10/538,542

Max Aebi

<b>Office Action Summary</b>	<b>Application No.</b> 10/538,542	<b>Applicant(s)</b> AEBI ET AL.	
	<b>Examiner</b> MICHAEL T. SCHAPER	<b>Art Unit</b> 3775

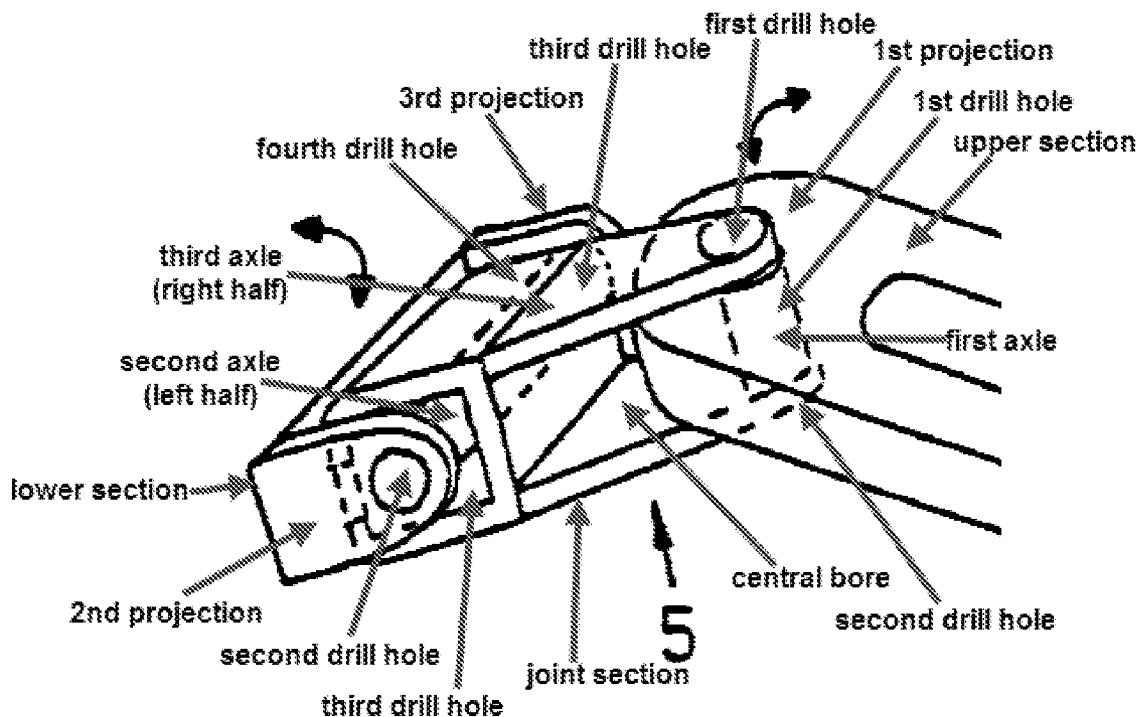
Stranders discloses a universal joint (see examiner-annotated FIG. 2 above) wherein the upper section having a first projection extending from the bottom surface, the first projection including a first drill hole; the lower section having second and third projections extending from the top surface, the second and third projections including second and third drill holes, respectively; and a frame shaped, central joint section located between the upper and lower sections so that the upper section is moveable with respect to the lower section, the central joint section including a central bore and first, second, third and fourth drill holes, the first projection extending from the bottom surface of the upper section being receivable within the central bore formed in the central joint section, the central joint section being receivable between the second and third projections extending from the top surface of the lower section so that a first axle is receivable in the first and second drill holes formed in the central joint section and the first drill hole formed in the first projection, a second axle is receivable in the third drill hole formed in the central joint section and the second drill hole formed in the second projection and a third axle, integral with the second axle, is receivable in the fourth drill
